CITY OF SOUTHGATE PLANNING COMMISSION AGENDA

PROPOSED NEW - GAS STATION

Carlisle | Wortman
ASSOCIATES, INC.

Special Condition and Site Plan Review

PROPOSED BACK ELEVATION
SCALE : 1/4"=1'-0"

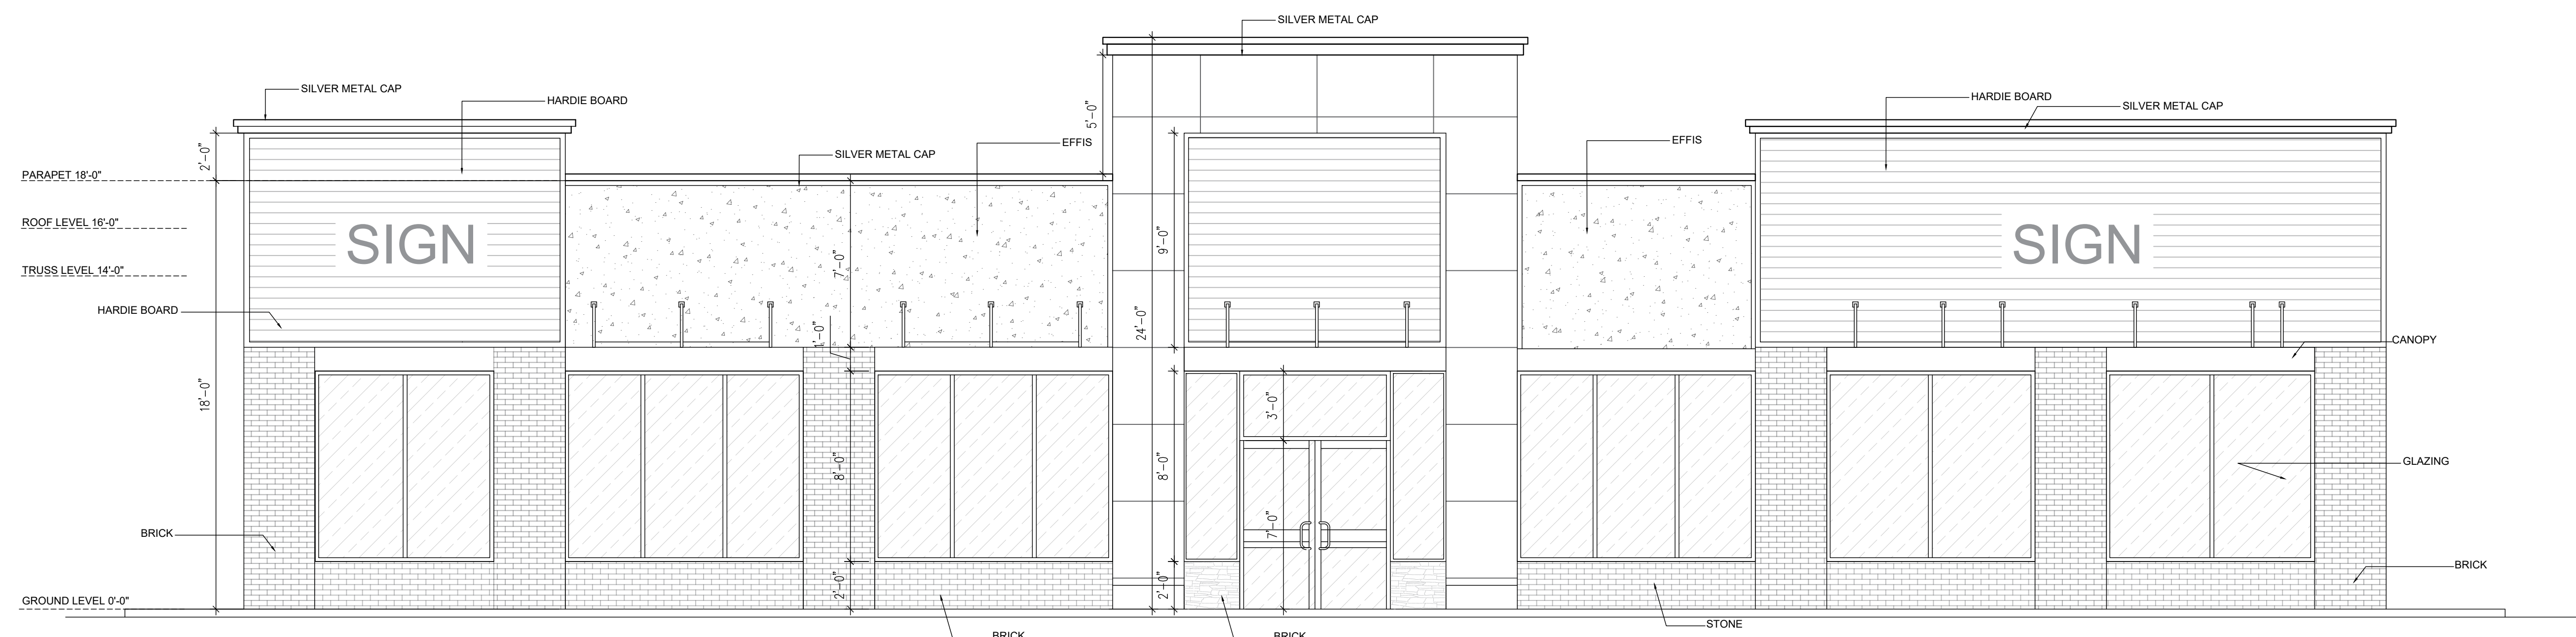
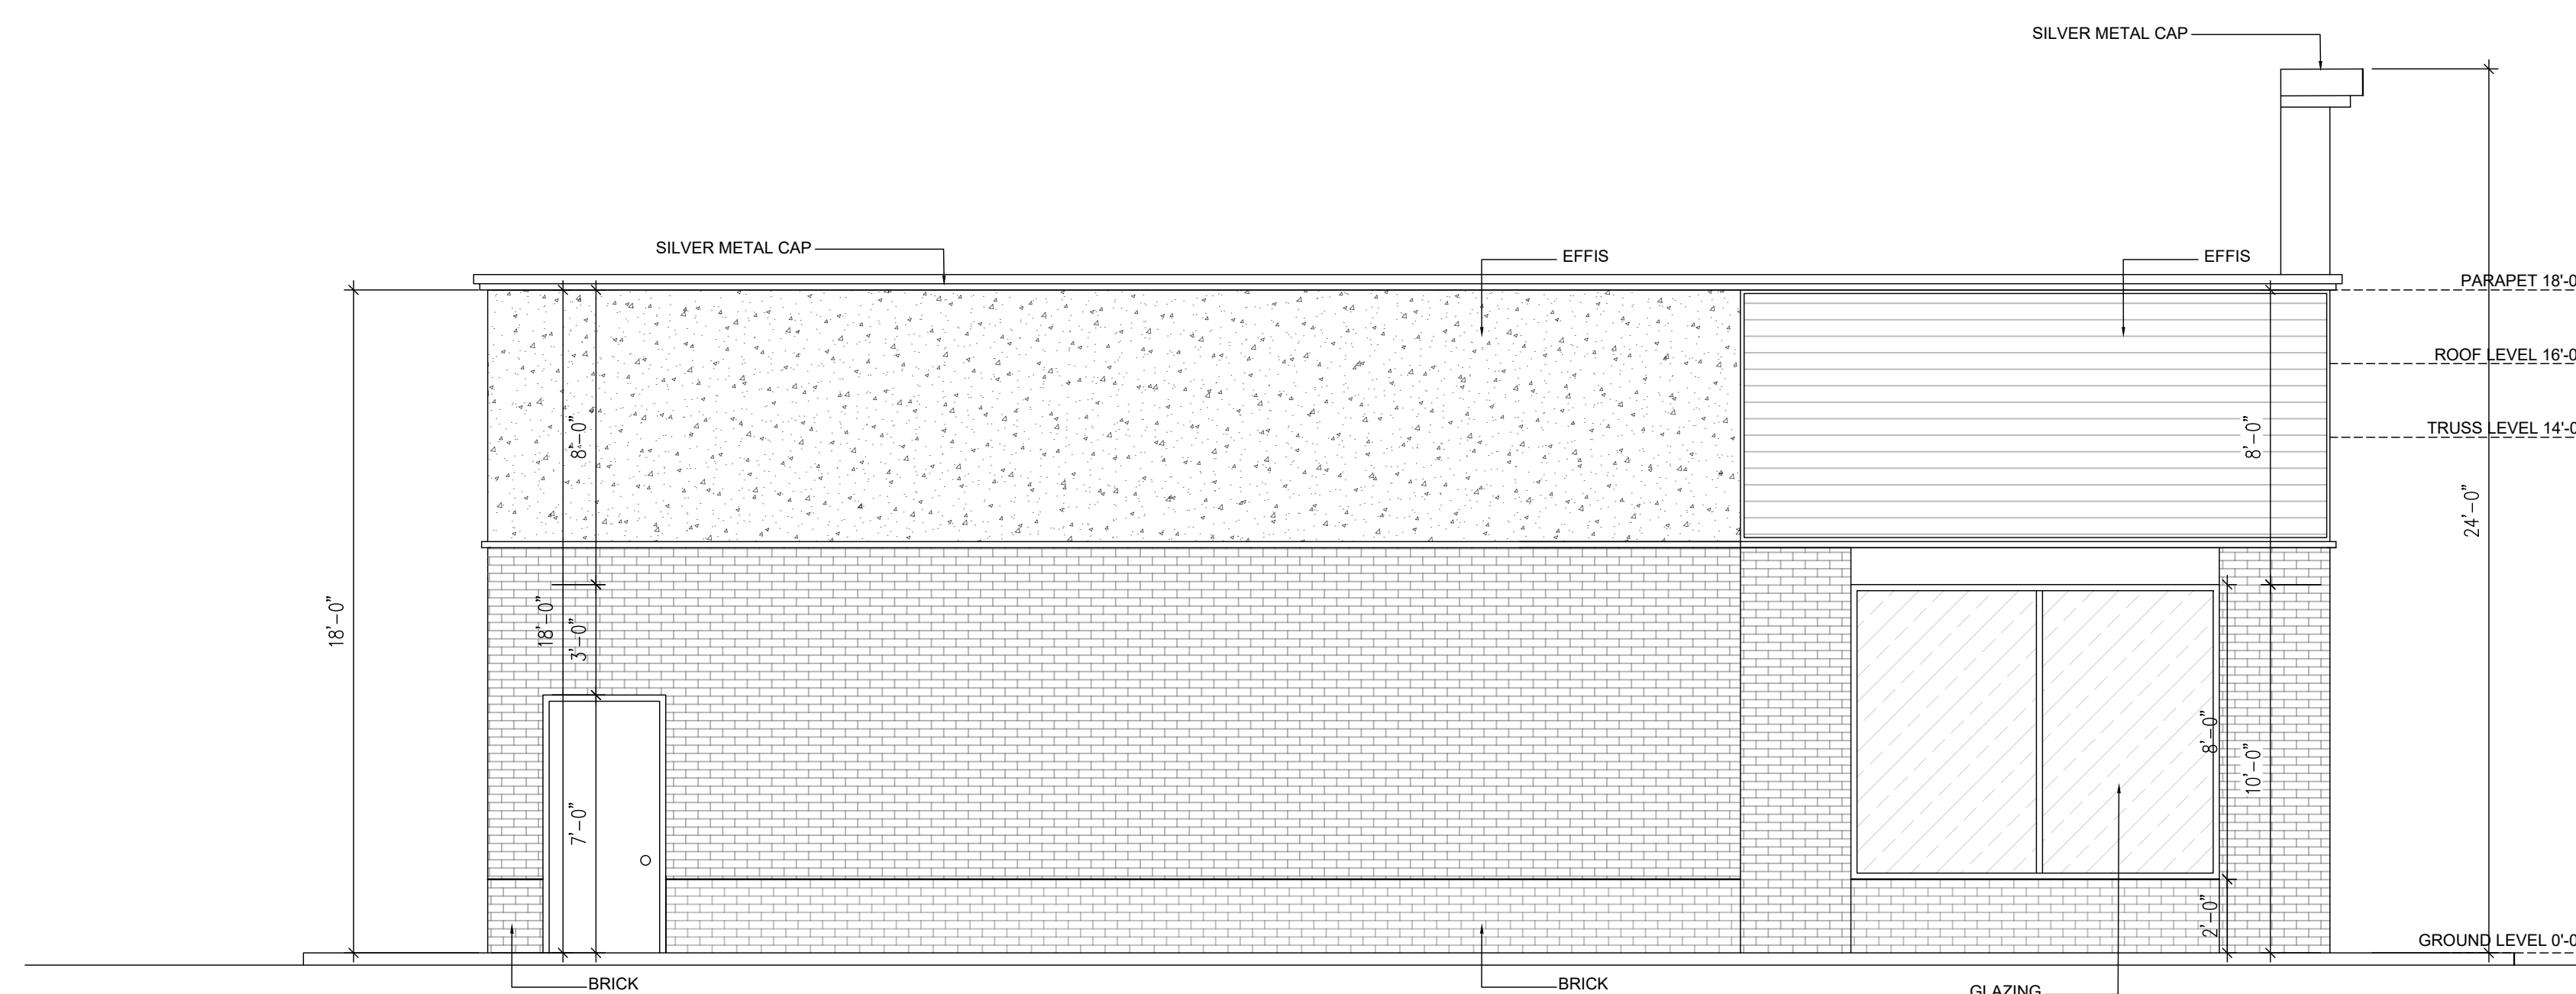
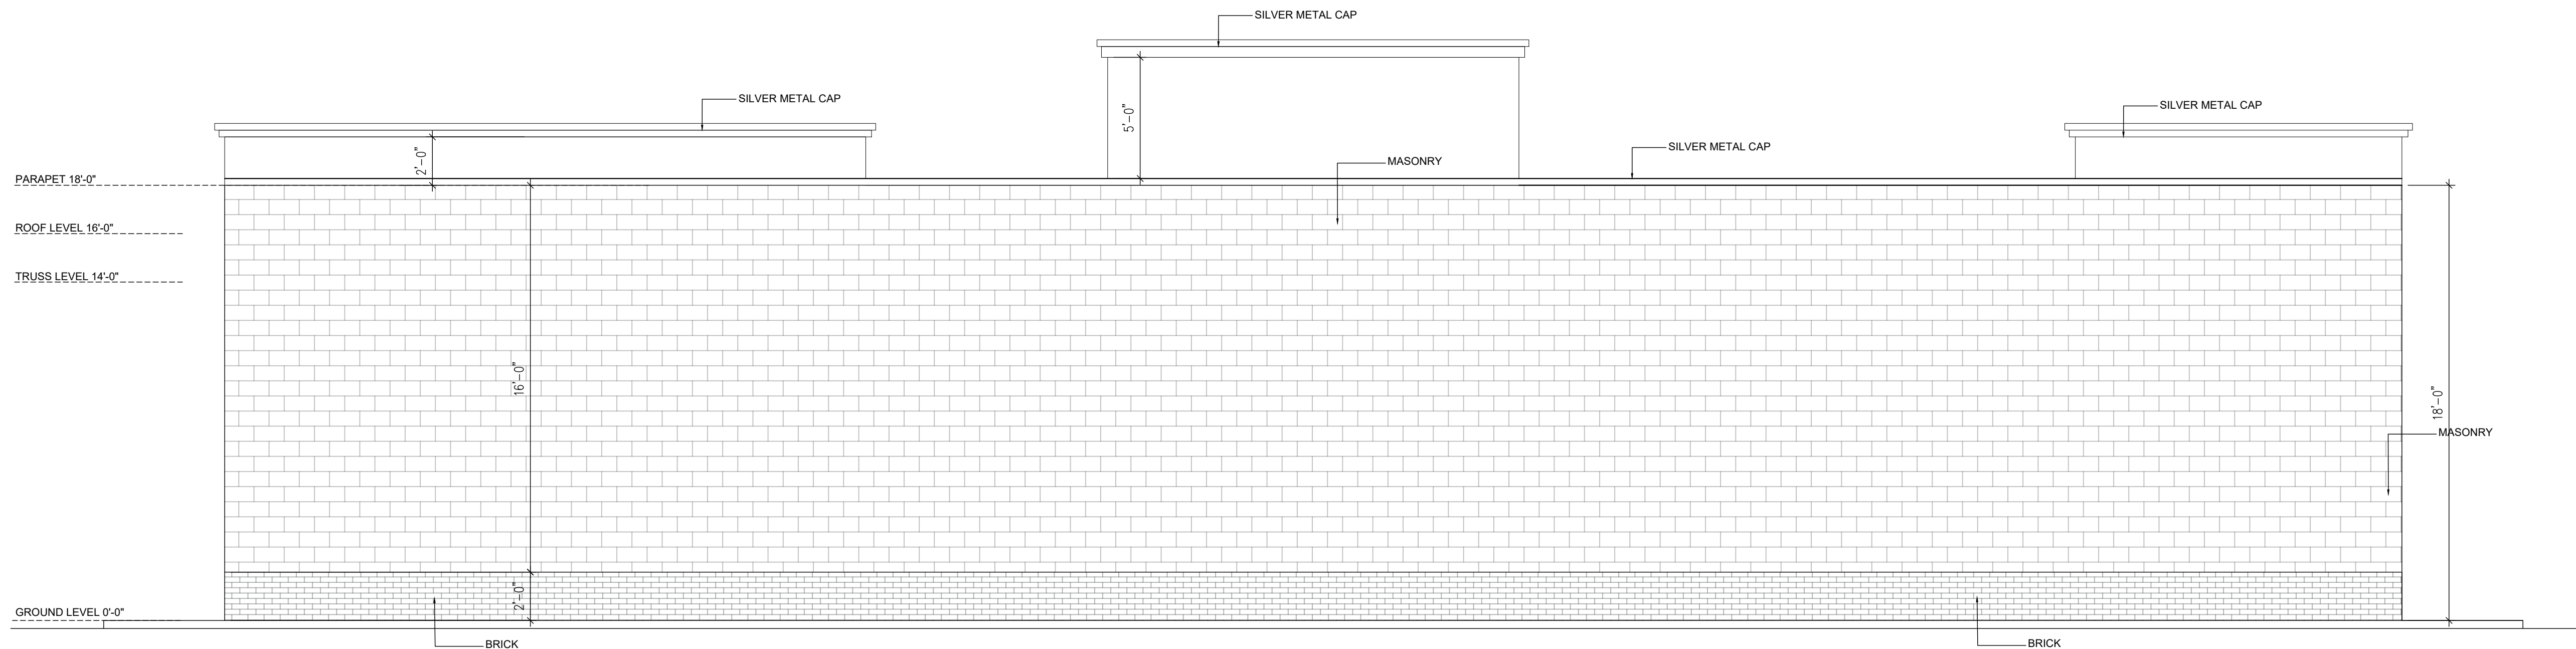
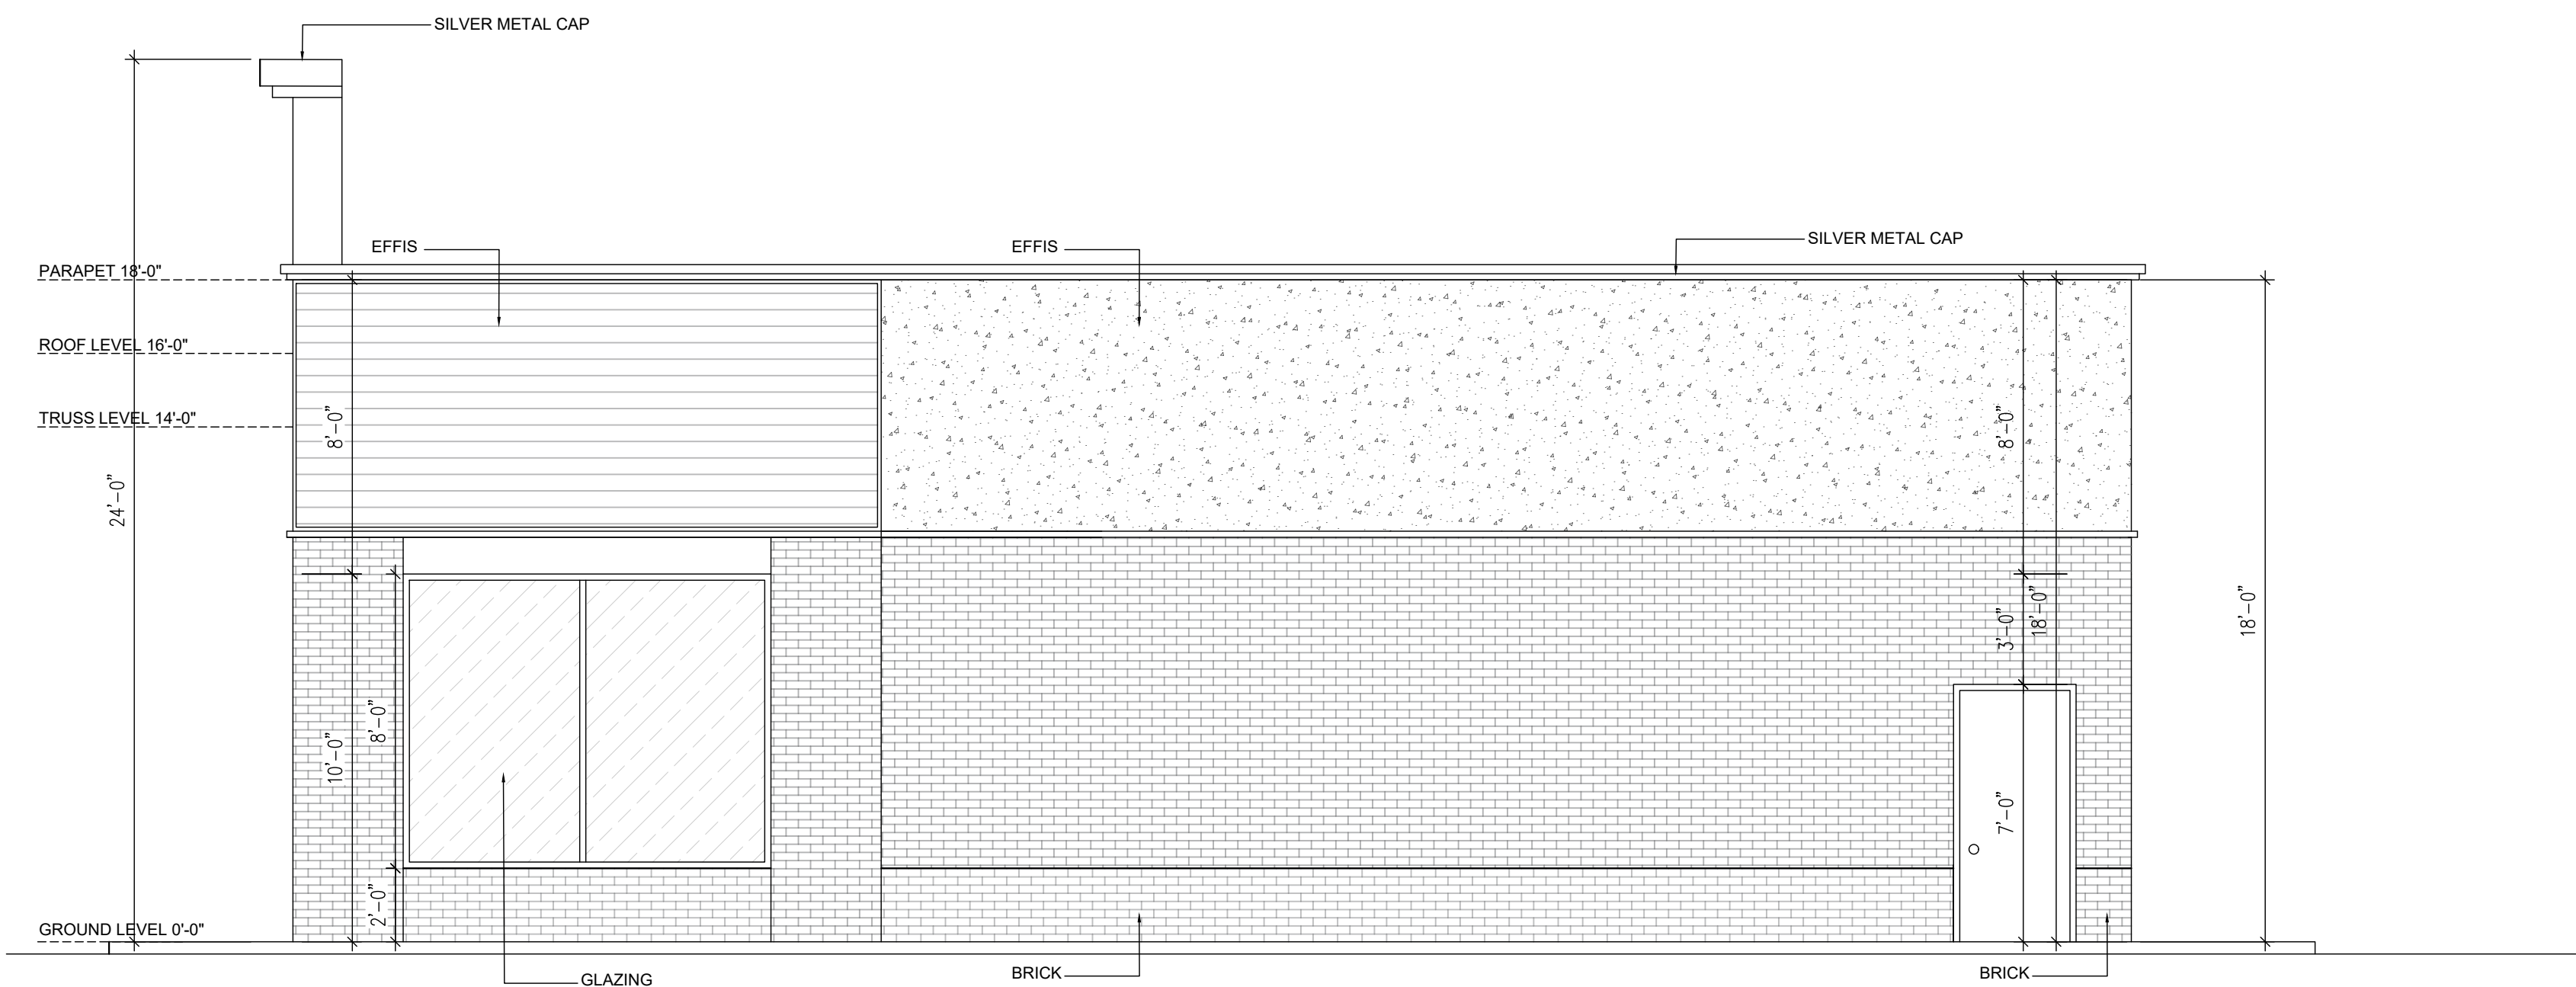
**As provided by section 1298.01(i), no interior side yard setbacks are required when a building wall has no openings. Building elevations on sheet A-103 indicate the western building elevation will have zero openings.
